DESIGN REVIEW & EXCELLENCE PANEL RESPONSE REPORT

14-16 MARSHALL AVE, 2-10 BERRY RD & 5-9 HOLDSWORTH AVE, ST LEONARDS

DEVELOPMENT APPLICATION

May 2023

4.3 North-west street corner

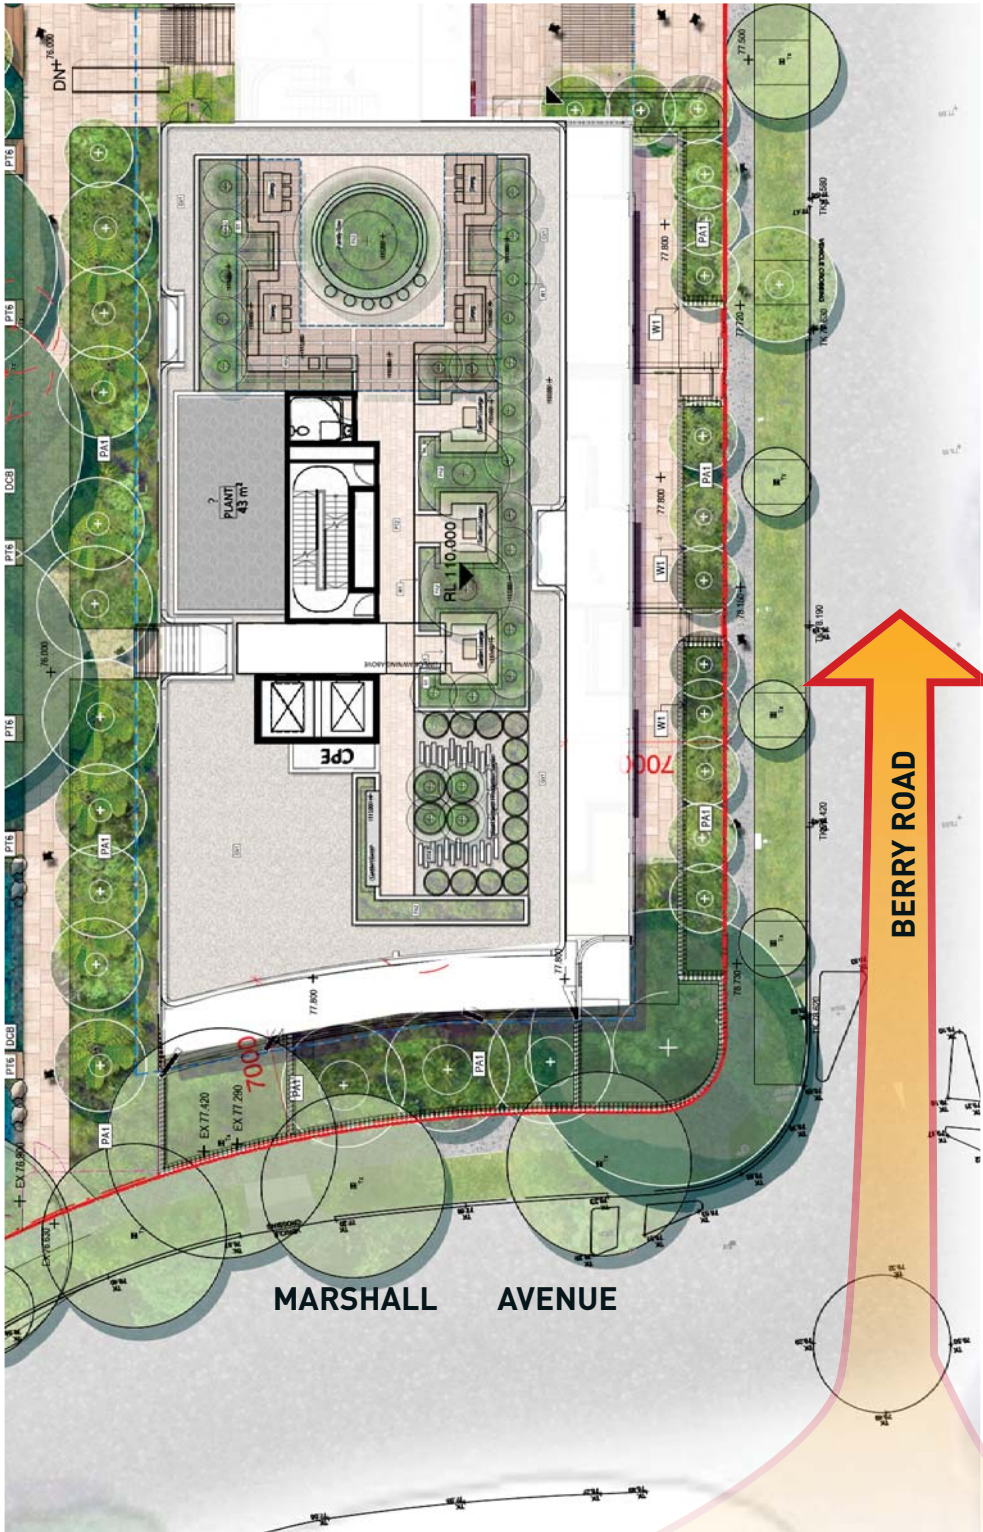
The introduction of transparent glass balustrade at Level 1 and vertical white components assist in providing an improved scale to the street and strengthening the corner. However this corner does still not achieve the strength of identity required to address the busy roundabout, nor the gateway significance of this corner to the South St Leonards Precinct.

The Northern Face of the building block of Area 13, has been modified to allow for a clear & cohesive definition to the gateway styled intersection of Marshall Avenue & Berry Road.

The Northern elevation of this project has been developed to continue the same abstracted brickwork patterned forms typical of the east and west elevations, in addition to this, the form of the upper tower has been revised to better define this important corner.

A visually permeable ground plane with private open spaces fronting the streets allows the street edge to provide a softly landscaped interface to the NW corner, which in effect forms the dominant character for the development.

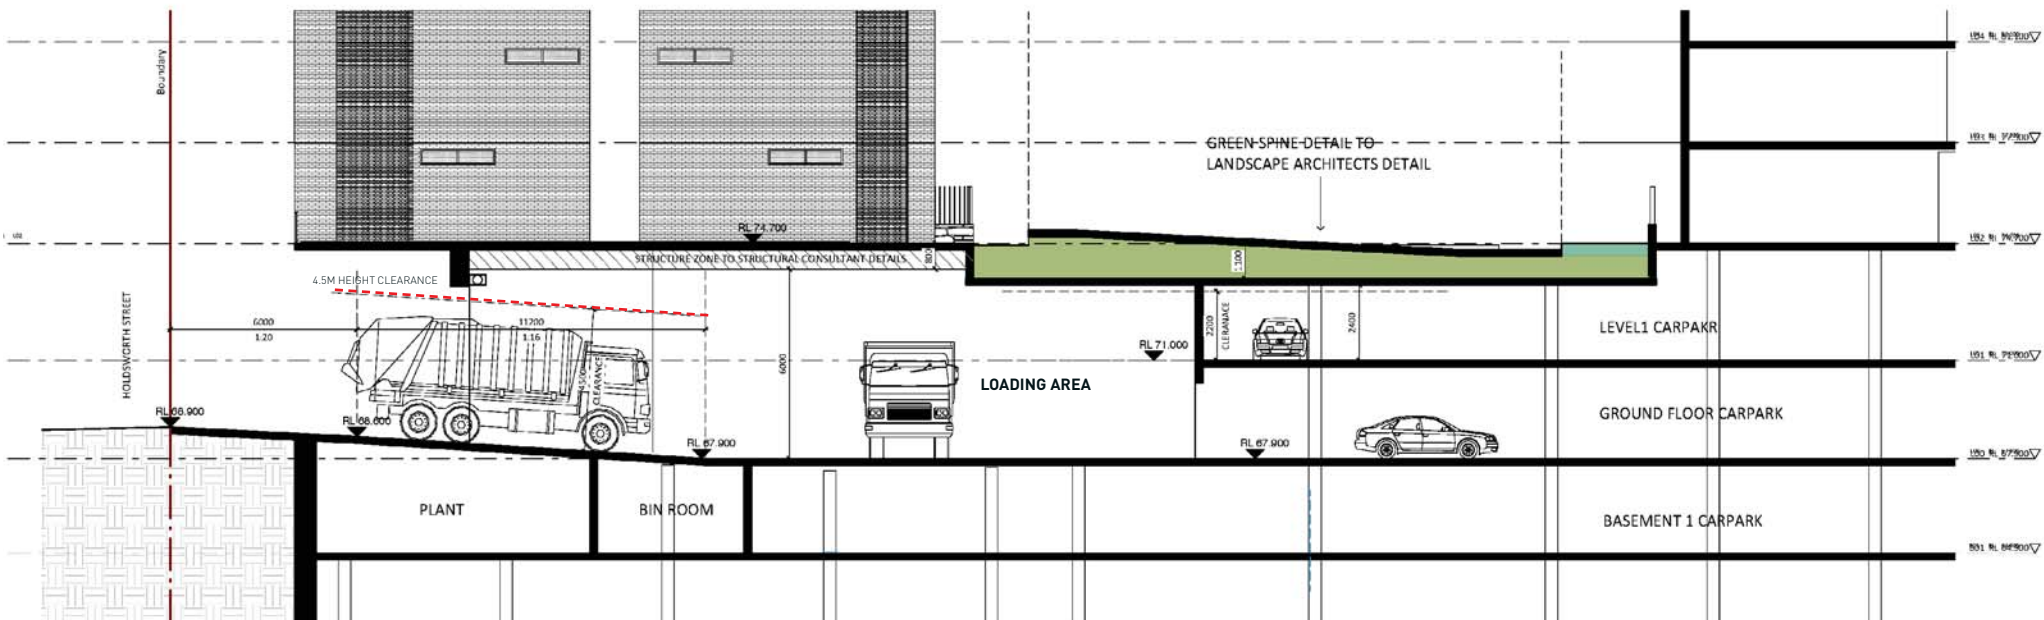
The Panel is not convinced that the loading and associated spaces are adequate for a complex of this size. The Applicant should provide design evidence that this loading allowance is adequate for deliveries (commercial and private), waste collection, service vehicles and maintenance operations. Provide detailed management plans that allow for all contingencies including but not limited to multiple arrivals, over stays, unintended turnarounds and the ability to function adequately whilst servicing 3 buildings.

A separately defined 1.8m wide double swing security door provides access for removalists from the loading dock onto individual floors via the lift lobby.

A dedicated loading area management plan has been proposed to help optimize the loading dock functionality and help manage operations during peak hours.

In addition, all loading area truck movements including any secondary deliveries will be managed by the building manager to manage any potential peak hour blockage.

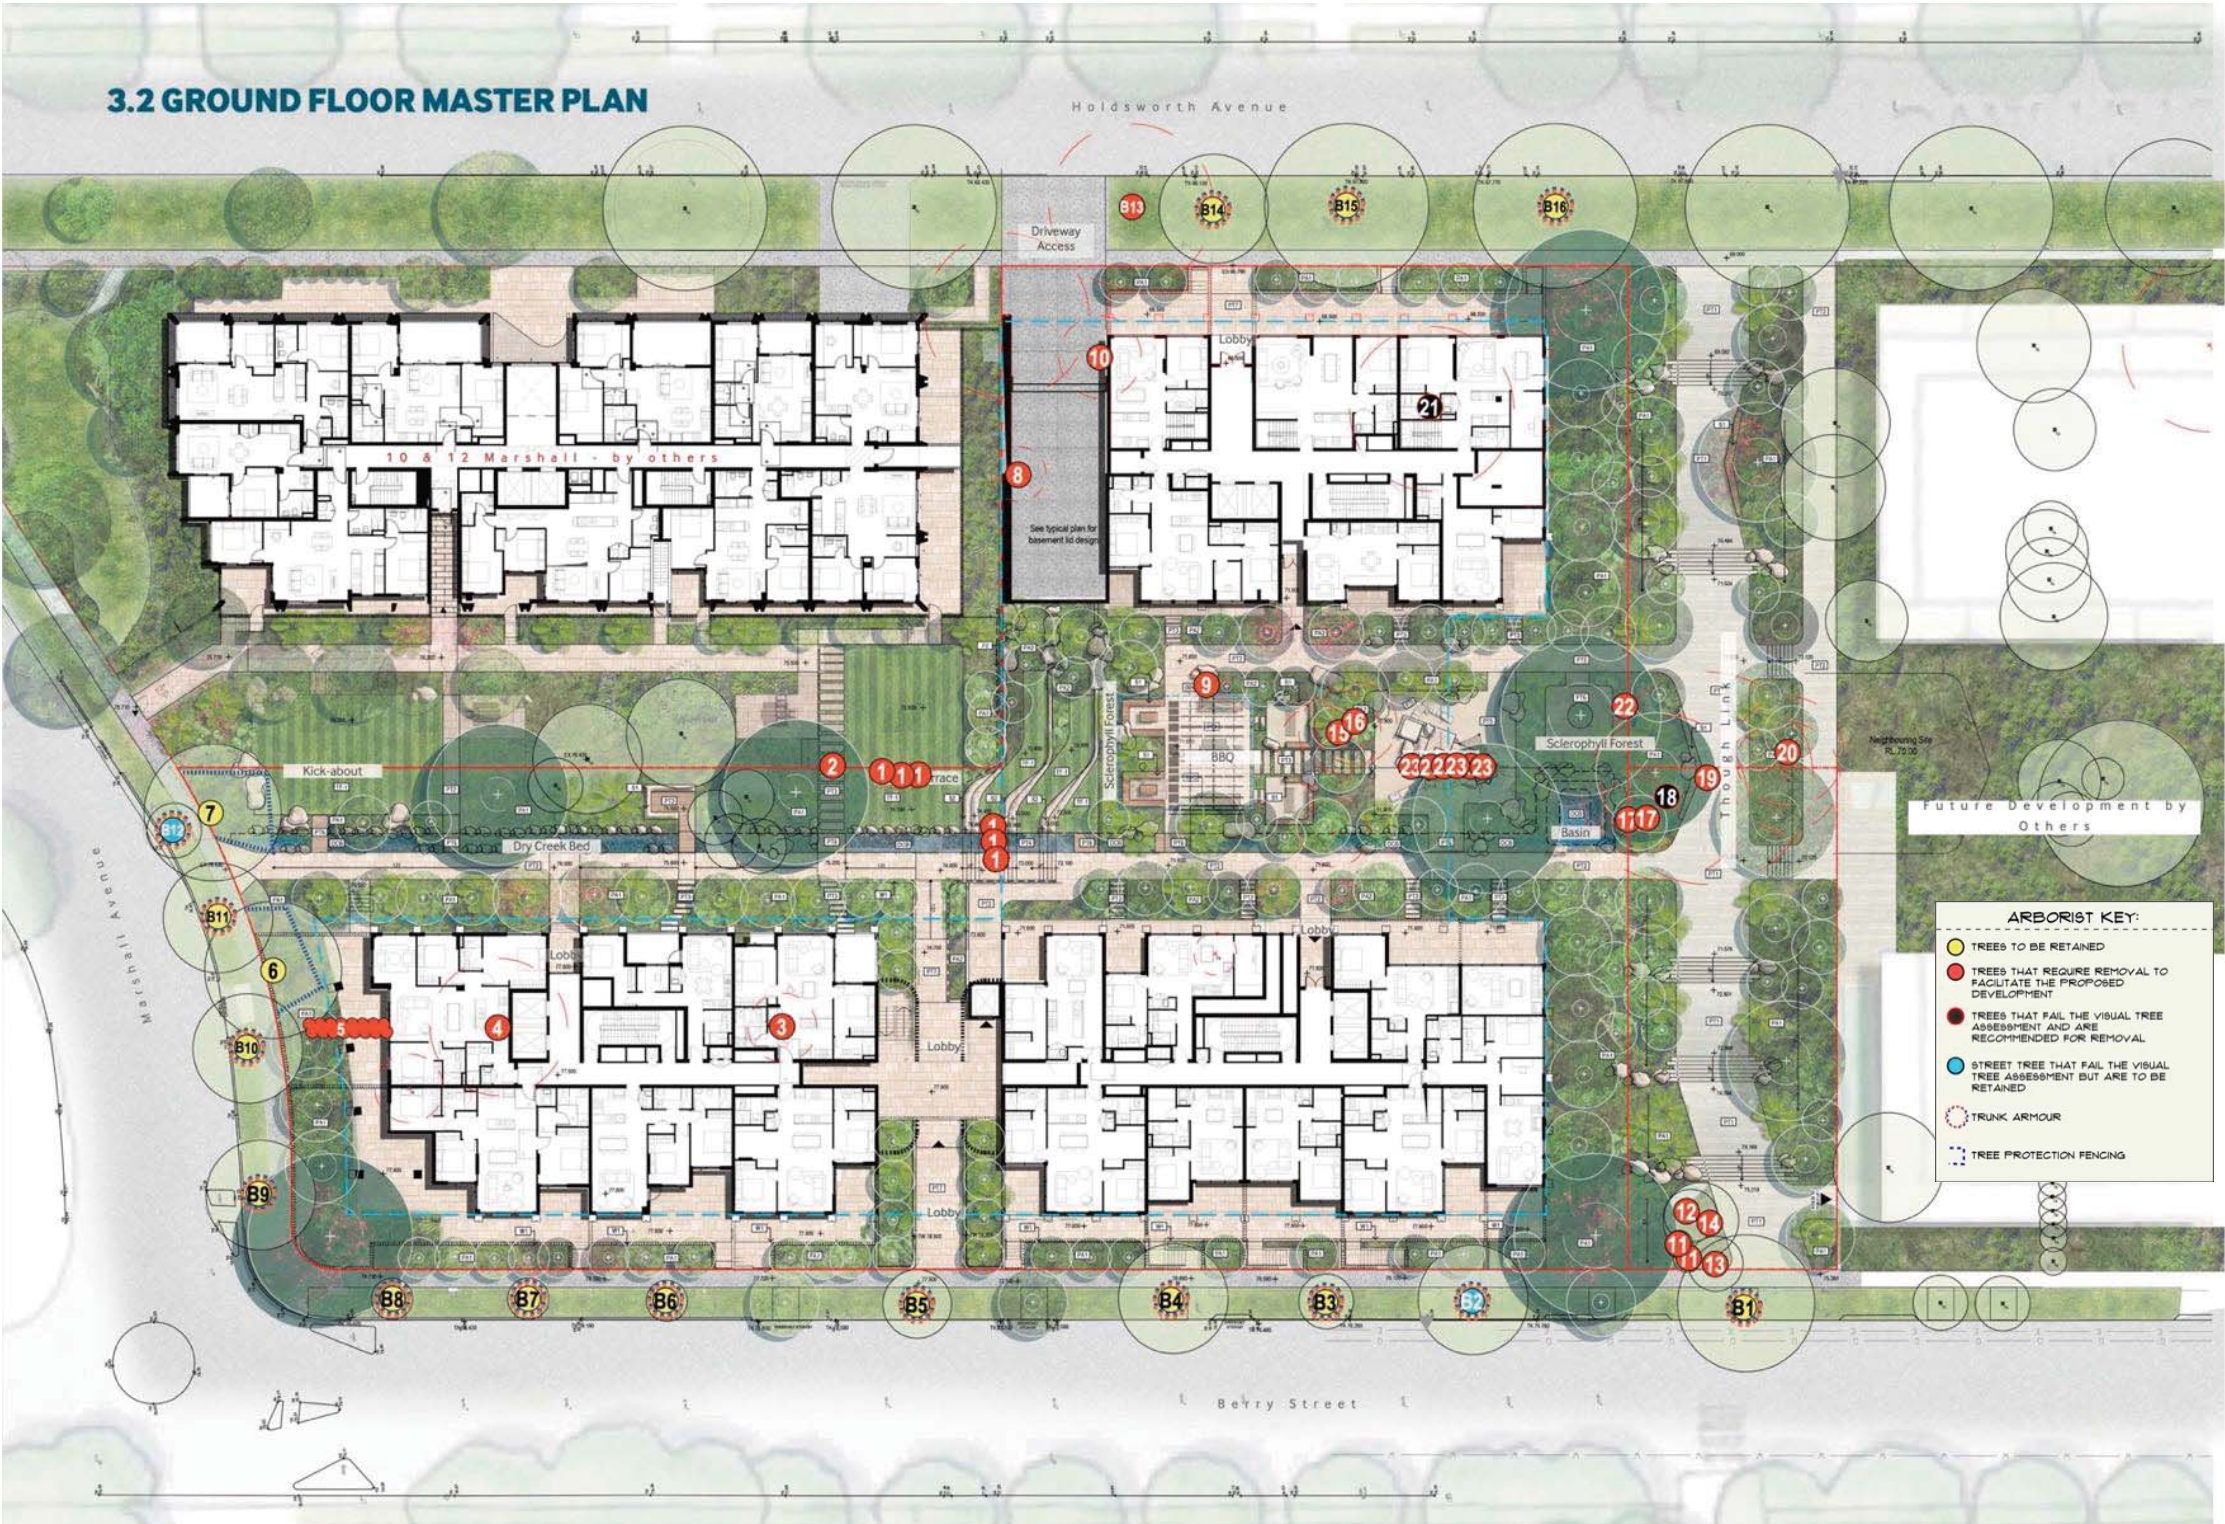
The landscape strategy is negatively impacted by the excessive number of storeys provided particularly to Block 14, where the opportunity exists to situate the outdoor area at a higher/existing level. Trees 9, 15,16 and 19 could be retained if the lower ground plane alters to provide a compliant number of storeys to Building 14. In addition Tree 9, a palm, could be salvaged and re-located.

Response:
Summary of Arborist’s Report -
An Arborist’s study conducted on the proposed development site, provides detailed observations on the contextual specificity, current condition, etc of the existing trees and makes the following recommendations -
Summary of Tree Schedule
Trees that pass the VTA (onsite) & ARE to be retained: 6 & 7.
Trees that fail the VTA & ARE recommended to be removed: 18 & 21.
Trees that require removal to facilitate the proposed development plans: 1, 2, 3, 4, 5, 8, 9, 10 11, 12, 13, 14, 15, 16, 17, 19, 20, 22, 23 & B13.
Street trees: B1, B3, B4, B5, B6, B7, B8, B9, B10, B11, B13, B14, B15, B16 & B17.
Street trees that fail the visual tree assessment: B2 & B12.

- The proposed development will have an acceptable impact on all the street trees with the exception of Tree B13 which will require removal to facilitate the proposed driveway access on Holdsworth Avenue.
- All Stormwater and Sewage plans will not impact any retained trees and this site will be subject to a landscape plan in which there will be many replacement trees included in the design.
- The retention of the majority of the street trees and the two significant trees on Marshal Avenue will ensure the streetscape amenity will not be altered in any way.
- When the landscape plan is completed, the areas’ long-term amenity will be greatly enhanced.

4.12 .07 Solar access

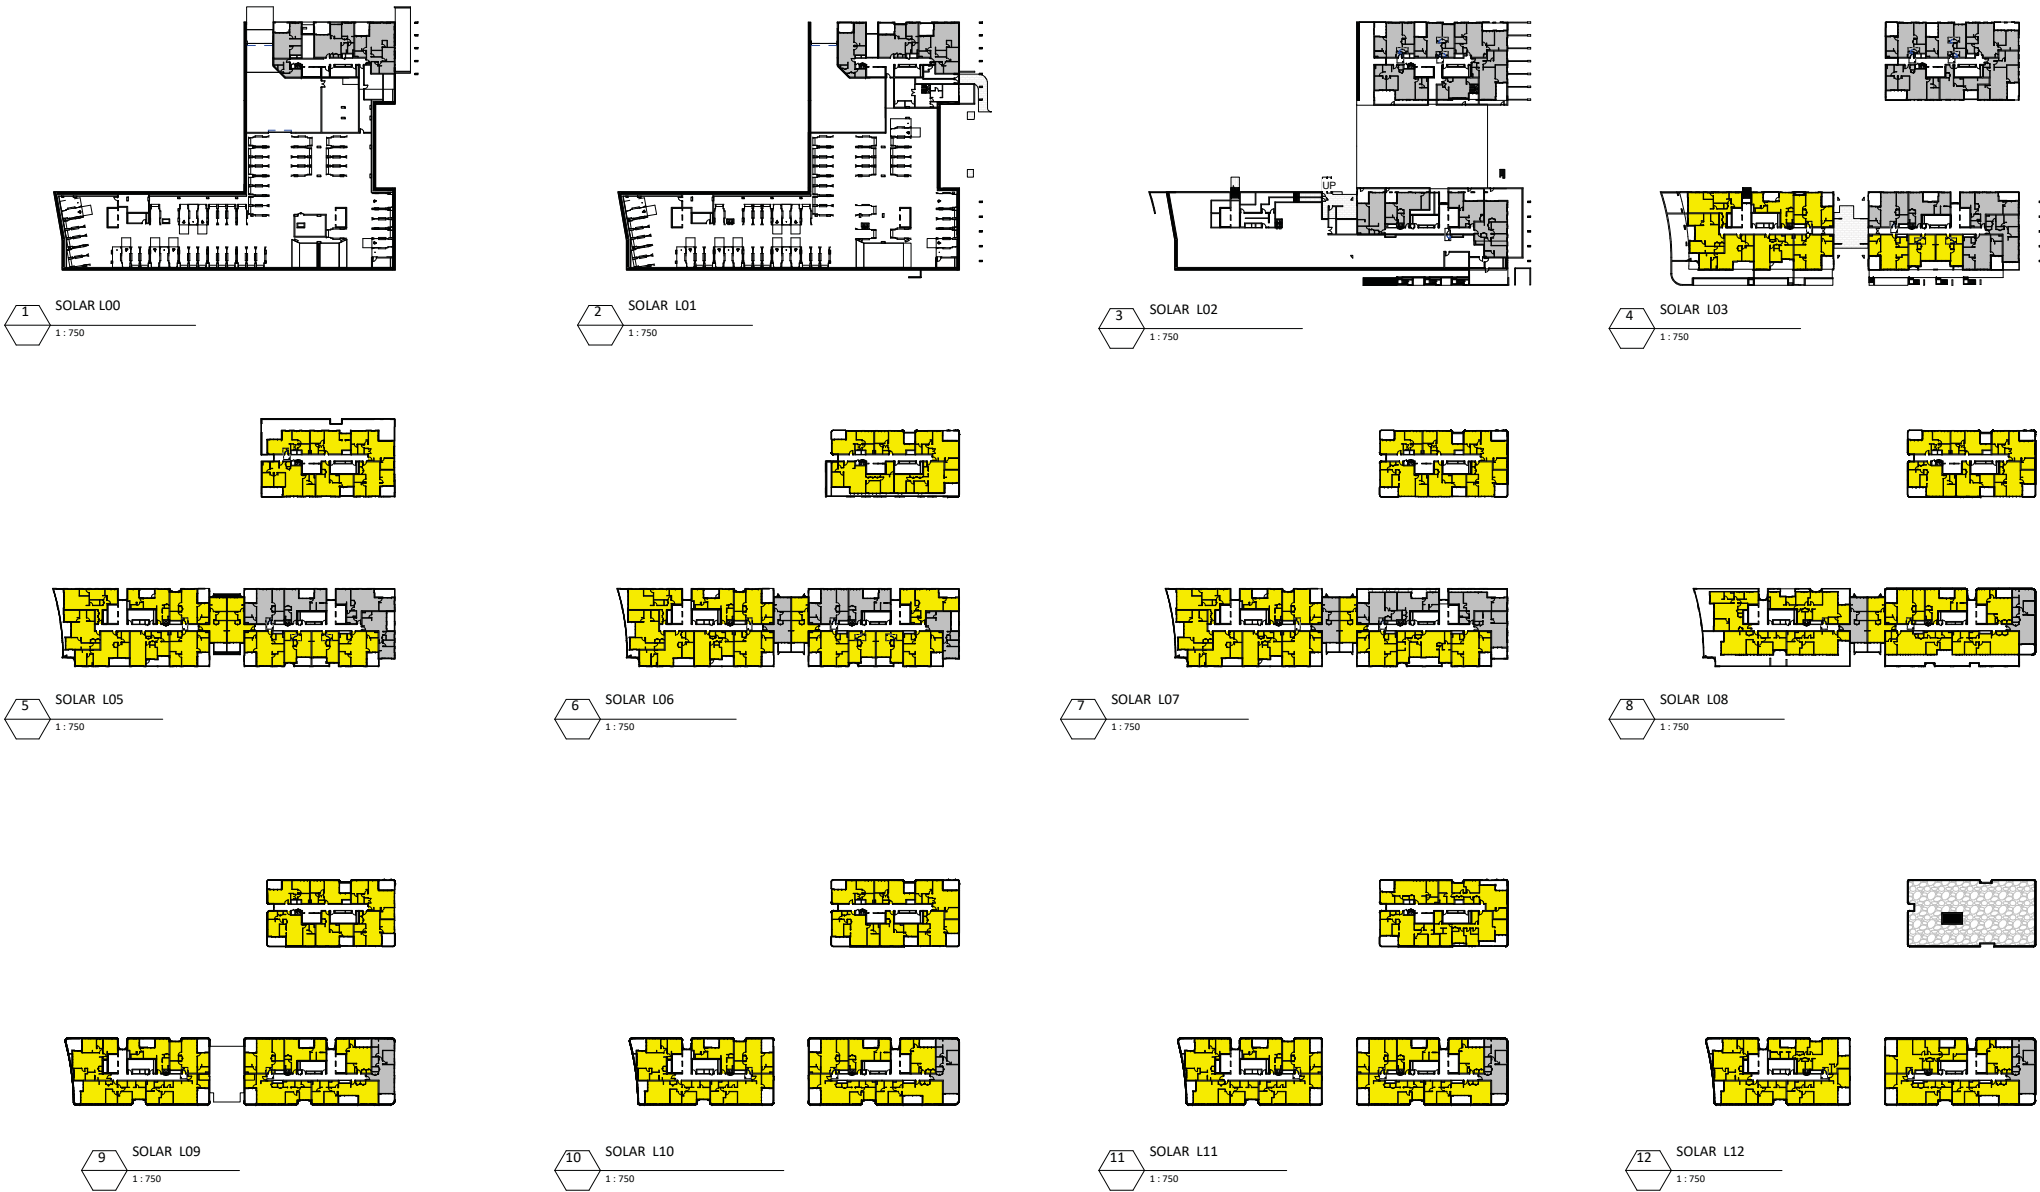
Review solar access to all east facing apartments and graphically demonstrate that 2 hours of sunlight is achieved to living spaces and private open spaces in accordance with Part 4A of the ADG.

Area 14 Solar Analysis
Solar Access to all East Facing Apartments -
Block 14 is located on a constraint portion of the site, where it is located on the lowest topography of the land, and it is naturally overshadowed by built forms located in area 13 and 15 to the west.
Despite that, careful apartment planning & optimal master plan orientation allows more than 61% of the units to have more than 2 hrs of solar access each day. The diagrams illustrate the availability of solar access to the eastern face of the building block on Area 14 from 9am up until 11:15am on the day of the Winter Solstice, beyond which the development located towards the Area 14's northern end starts to block its access to sunlight. The development overall can achieve solar access to 71.6% of the apartments.
